Southern Nuclear Operating Company
Vogtle Electric Generating Plant Units 3 and 4
Request for License Amendment:
Structural Design of Auxiliary Building Floors (LAR-16-000)

- Enclosures:
- 1) Vogtle Electric Generating Plant (VEGP) Units 3 and 4 – Request for License Amendment Regarding Structural Design of Auxiliary Building Floors (LAR-16-000)
 - 2) Vogtle Electric Generating Plant (VEGP) Units 3 and 4 – Proposed Changes to Licensing Basis Documents (LAR-16-000)

Request for License Amendment Regarding
Structural Design of Auxiliary Building Floors
(LAR-16-000)

DESIGN SUMMARY OF FLOOR AT ELEVATION 135'-3"
AREA ~~4-2~~ (MAIN CONTROL ROOM CEILING)

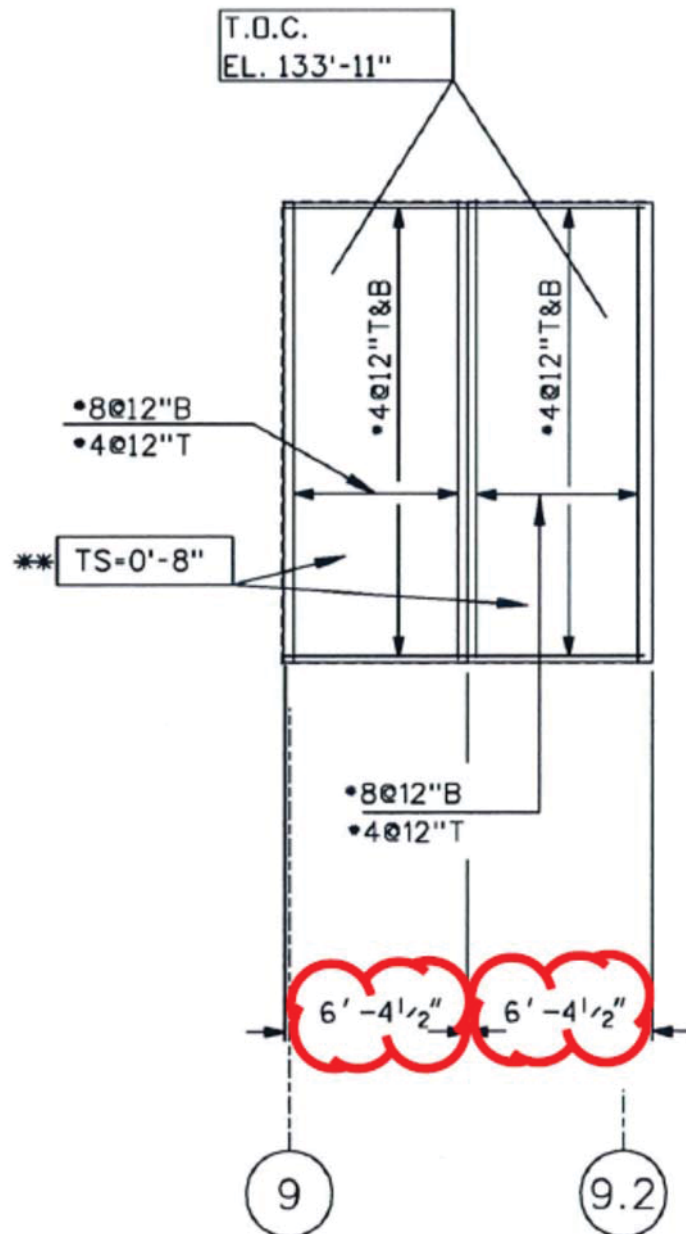
UFSAR Table 3H.5-13, Design Summary Of Floor At Elevation 135'-3" Area 1 (Main Control Room Ceiling) – Revise the title of this table to read as shown below.

UFSAR Table 3H.5-13, Design Summary Of Floor At Elevation 135'-3" Area 1 (Main Control Room Ceiling) – Revise the information in the table as shown below.

Change the values in UFSAR Table 3H.5-13 to reflect the revised design and calculation. Reformat and revise the information in the table to present the information in a more understandable manner. The calculated results from the design evaluation for maximum bending moment and maximum shear force are removed from the table. These values represent only a small portion of the floor. The acceptance criteria used to evaluate the floor design is the criteria in ACI 349. The maximum bending moment and maximum shear force specified in the table are not the acceptance criteria for the floor design. The reinforcement included to resist negative bending provided by the design is added to the table to provide additional information about the floor design instead of information about bending moment. Add a statement that excludes reinforcement and studs in the area of penetrations, openings, or other obstructions. Change the designation of the area in the table title. Change the reference to the table number in UFSAR Subsection 3H.5.4 from "3.H.5-13" to "3H.5-13."

- H. Revise UFSAR Table 3H.5-13 to remove the calculational results for maximum bending moment and maximum shear force. Revise UFSAR Table 3H.5-13 to add values to the table for the reinforcement to resist negative bending. Revise the table title to correct the area in the title. Add an exception for shear studs near penetrations and other interferences. (Change Activity 7)

FLOOR EL. 133'-11"
(PRECAST CONCRETE)
NOTES 1, 3, 6, 7, 16, 17

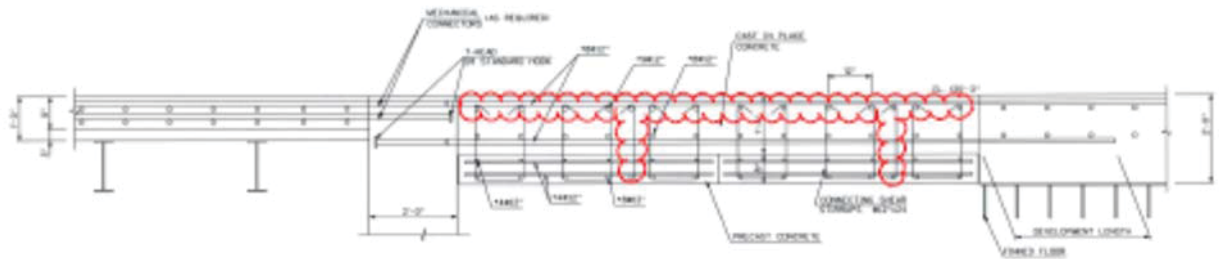
**UFSAR Figure 3H.5-8, Auxiliary Building Operations Work Area (Tagging Room) Ceiling –
Revise the information for Floor EL. 133'-11" (Precast Concrete) as shown below.**

- I. Change to UFSAR Figure 3H.5-8 (Change Activity 9):
1. In the view labeled Floor EL. 133'-11" (Precast Concrete), change the panel width from 5'-11" to 6'-4½"

**UFSAR Figure 3H.5-8, Auxiliary Building Operations Work Area (Tagging Room) Ceiling –
Revise the information for Section C (Looking West) as shown below.**

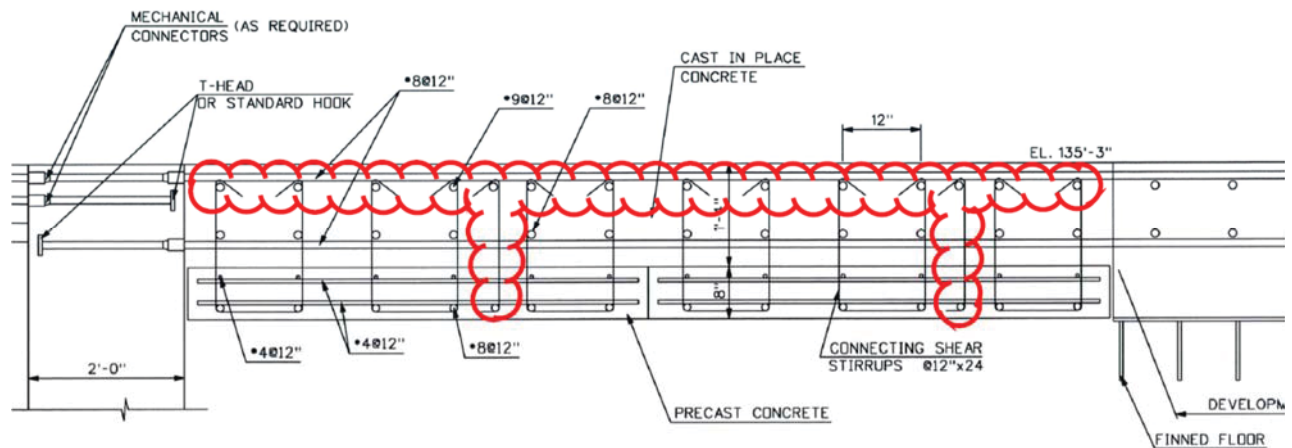
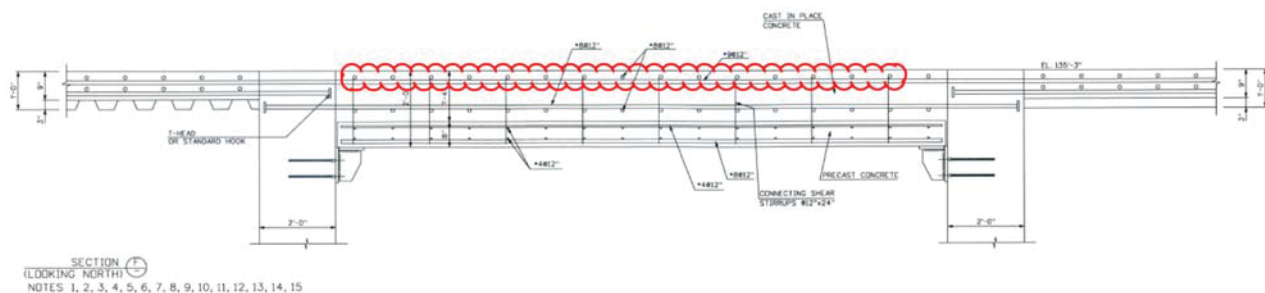
Additional detail of changed area.

Revise UFSAR Subsection 3H.5.3.1 and UFSAR Figure 3H.5-8 to show the width of the precast panels to be 6'-4½". Revise UFSAR Figure 3H.5-8, Section C, to show three double stirrups and one single stirrup connecting the precast panel and cast-in-place concrete. Revise UFSAR Figure 3H.5-8, Sections C and F, to show the hooks on the stirrups to be in the plane of the bends to make them double hooks.

2. In Section C, add a row of single stirrups to each of the two precast panels.
 3. In Section C and F, reorient the hooks on the stirrups to be in the plane of the double stirrup.

**UFSAR Figure 3H.5-8, Auxiliary Building Operations Work Area (Tagging Room) Ceiling –
Revise the information for Section F (Looking North) as shown below.**

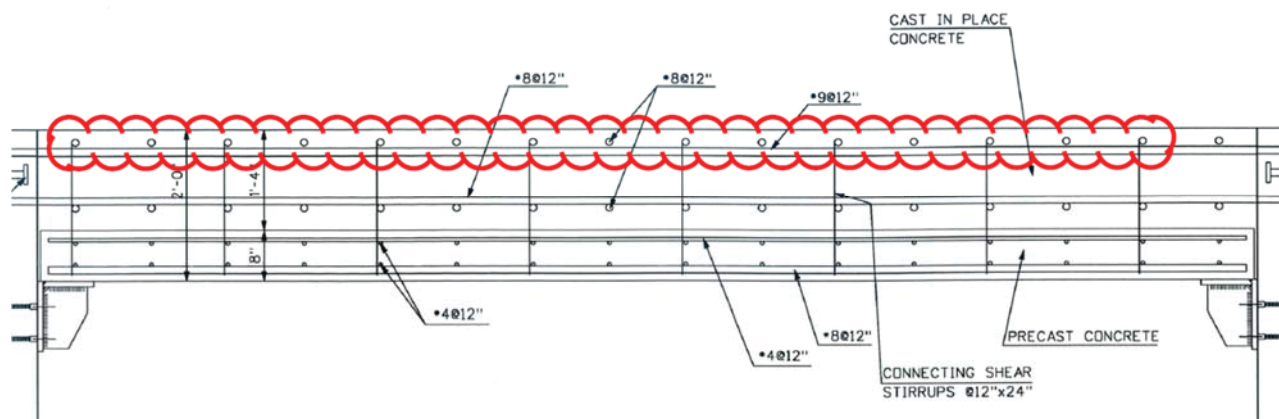
Additional detail of changed area.

UFSAR Figure 3H.5-9 (Sheet 1 of 3), Auxiliary Building Finned Floor – Revise the information as shown below.

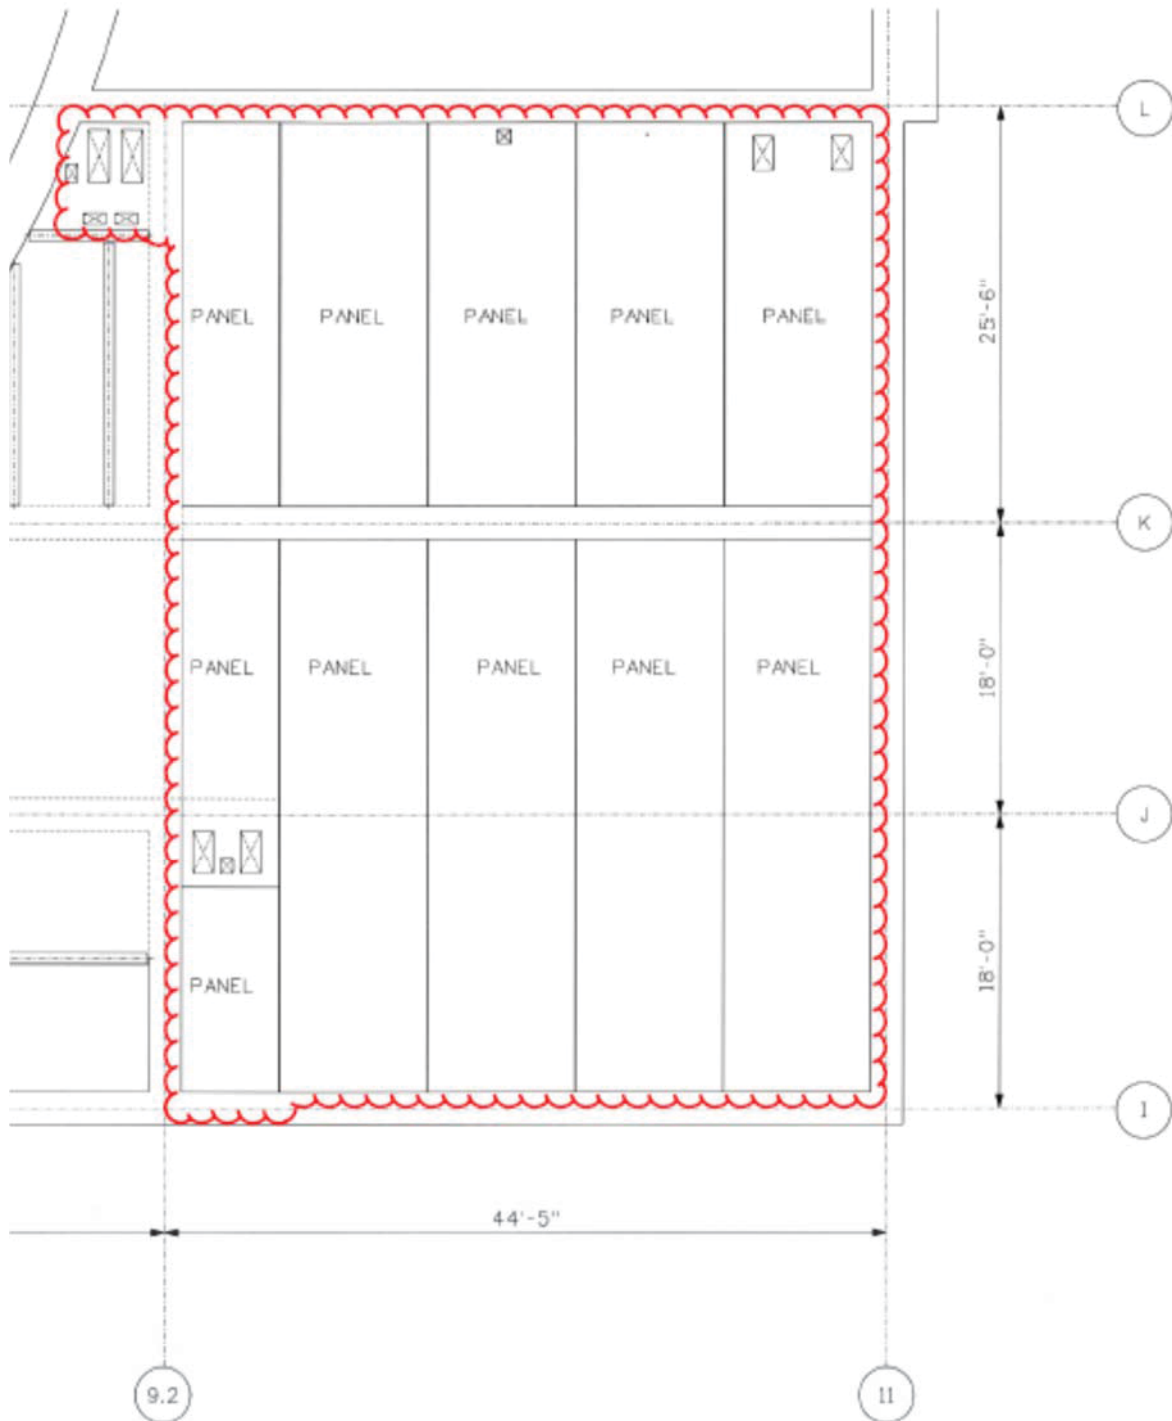
UFSAR Figure 3H.5-9 (Sheet 1 of 3), Auxiliary Building Finned Floor – Revise the information to add the Notes shown below.

1. DETAIL SHOWN IS SPECIFIC TO THE REINFORCED CONCRETE FLOOR AT EL. 135'-3" (MAIN CONTROL ROOM CEILING). REFER TO SUBSECTION 3H.5.4 AND OTHER NOTES FOR ADDITIONAL INFORMATION ABOUT DESIGN DETAILS FOR OTHER FLOOR SECTIONS AND FOR CONNECTIONS TO WALLS OTHER THAN THE WALL ALONG COLUMN LINE 11.
2. THE NUMBER OF STEEL PANELS USED TO CONSTRUCT THE FLOOR IS DETERMINED BY THE SIZE OF THE ROOM AND FABRICATOR CAPABILITIES.

- J. Change to UFSAR Figure 3H.5-9, Sheet 1 (Change Activities 1, 3, and 4):
1. Revise the figure to show five finned floor steel plates between Column Lines 9.2 and 11 from Column Lines I to L.

2. Revise the figure to move the rectangular openings for HVAC ducts from along Column Line 11 near Column Lines I and J to along Column Line L near Column Line 11.

3. Add notes to the figure to provide the following information:
 - a. State that the section shown is a specific location and other locations will have variations in design details.

- b. State that the number of steel panels in the floor varies.
- K. Revise UFSAR Figure 3H.5-9, Sheet 2 as follows: (Change Activities 1, 2, 5, and 8):

UFSAR Figure 3H.5-9 (Sheet 2 of 3), Auxiliary Building Finned Floor – Revise the information to add the Notes shown below.

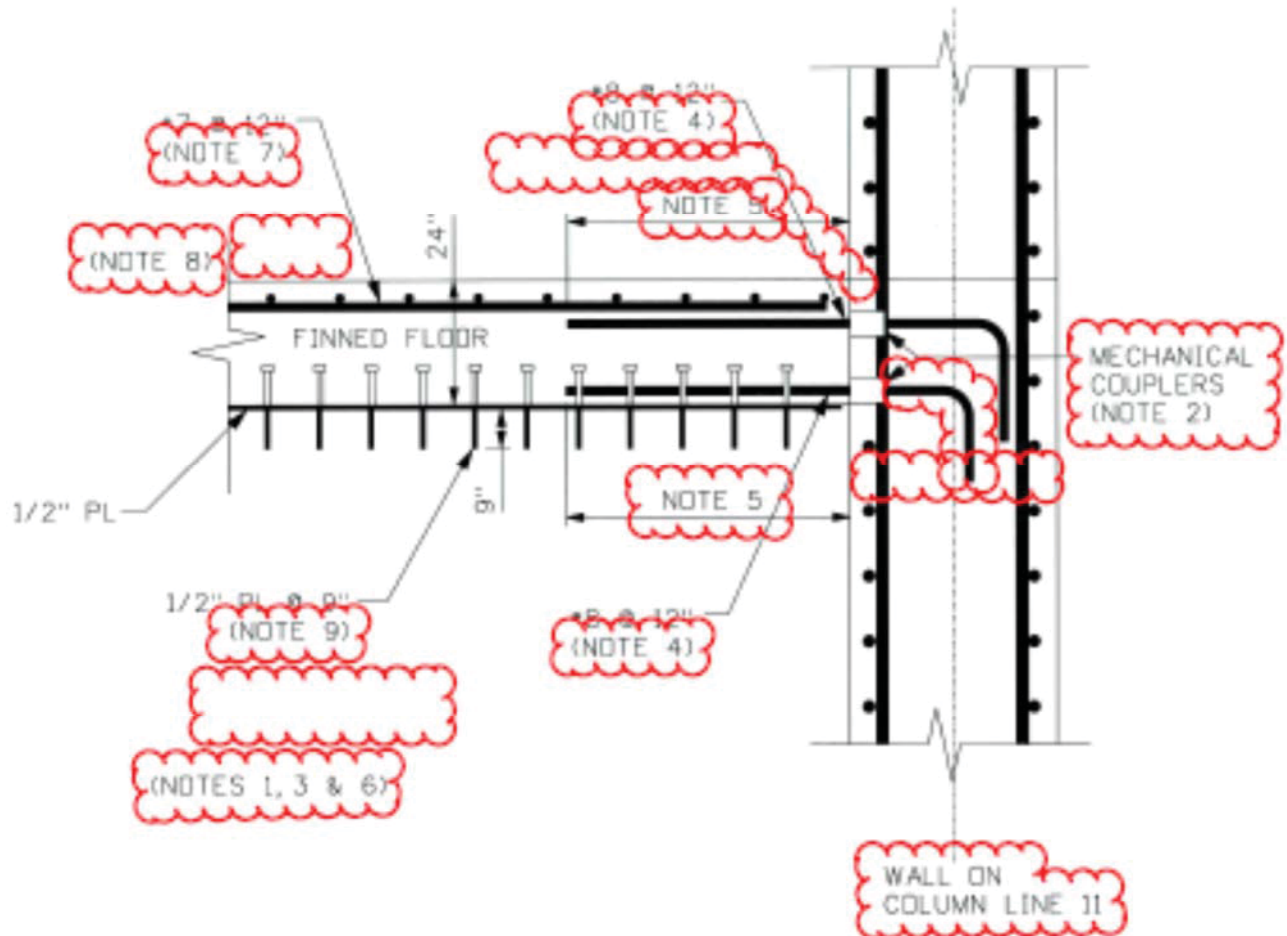
UFSAR Figure 3H.5-9 (Sheet 2 of 3), Auxiliary Building Finned Floor – Revise the information to add the Notes shown below.

1. DETAIL SHOWN IS SPECIFIC TO THE REINFORCED CONCRETE FLOOR AT EL 135'-3" (MAIN CONTROL ROOM CEILING). REFER TO SUBSECTION 3H.5.4 AND OTHER NOTES FOR ADDITIONAL INFORMATION ABOUT DESIGN DETAILS FOR OTHER FLOOR SECTIONS AND FOR CONNECTIONS TO WALLS OTHER THAN THE WALL ALONG COLUMN LINE 11.

7. THE REINFORCEMENT SHOWN IS FOR LOCATIONS AWAY FROM OPENINGS, PENETRATIONS, EMBEDMENTS, AND OTHER OBSTRUCTIONS. THE RANGE OF REINFORCEMENT SIZE AND SPACING VARIES FROM #7@12" TO #11@6".

8. THE ELEVATION OF THE TOP OF CONCRETE IS BASED ON LOCATION AND DESIGN REQUIREMENTS FOR THE FLOORS.
9. THE DESIGN OF THE FINS VARIES AT LOCATIONS NEAR OPENINGS, PENETRATIONS, AND OTHER OBSTRUCTIONS AND DUE TO ATTACHMENTS TO THE FINS AND FLOOR PLATES.

1. Revise figure to show both hooks in wall turned down
 2. Remove reference to construction joint
 3. Remove designation of 135'-3" elevation; replace with Note 8

4. Remove size of dowel length; replace with Note 5
 5. Remove information on gap between steel plate and wall
 6. Replace the term "Mechanical Splices" with "Mechanical Couplers"

7. Remove North – South designator
 8. Revise wall designation to say "Wall on Column Line 11"

9. Add notes to the figure to provide the following information:
 - a. State that the section shown is a specific location and other locations will have variations in design details.

- b. State that headed reinforcement may be used.
 - c. Identify the requirements for development of headed reinforcement.
 - d. Identify the code requirements for reinforcement size and spacing and provide the range of reinforcement size and spacing.

- e. Identify the requirements for dowel length.
 - f. Discuss bottom layer reinforcing steel provided for structural integrity of the fire barrier.
 - g. State that the reinforcement shown is for locations away from obstructions.

- h. State that the elevation of the top of concrete is based on location and design requirements for the floors.
 - i. State that the design of the fins varies at locations near obstructions and due to attachments to the fins and floor plates.

UFSAR Figure 3H.5-9 (Sheet 3 of 3), Auxiliary Building Finned Floor – Revise the information to add Notes as shown below.

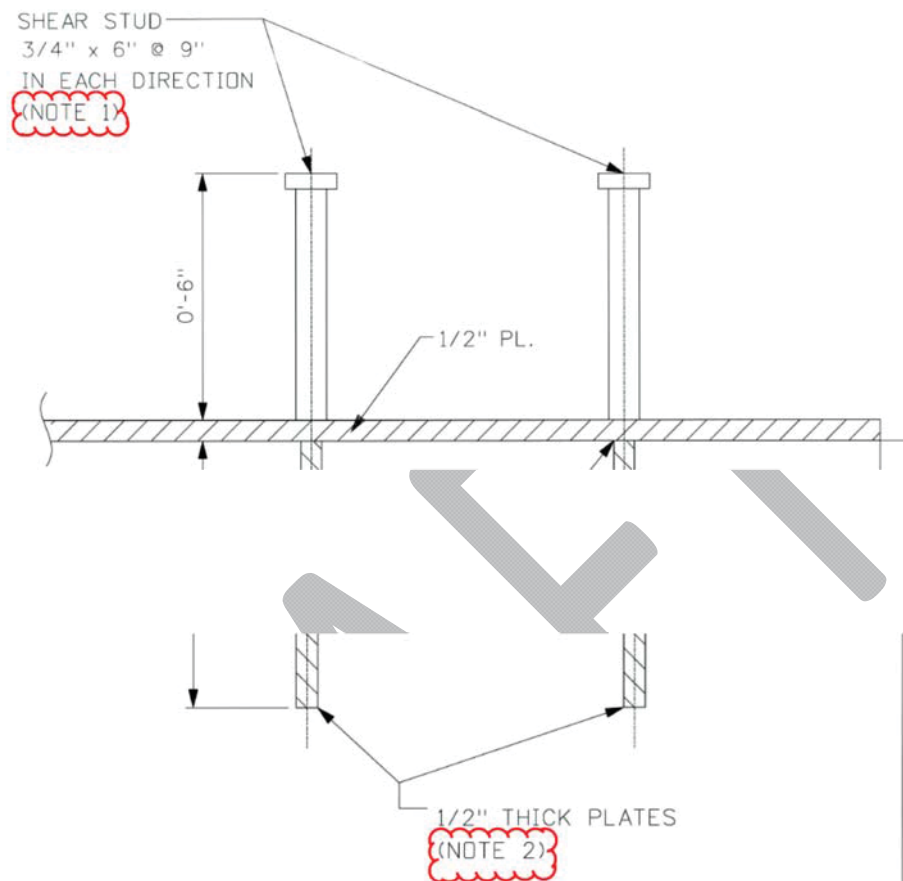
NOTES:

L. Revise UFSAR Figure 3H.5-9, Sheet 3 as follows: (Change Activity 1):

1. Add notes to the figure to provide the following information:
 - a. State that the shear stud design shown is for locations away obstructions.
 - b. State that the design of the fins varies at locations near obstructions and due to attachments to the fins and floor plates.
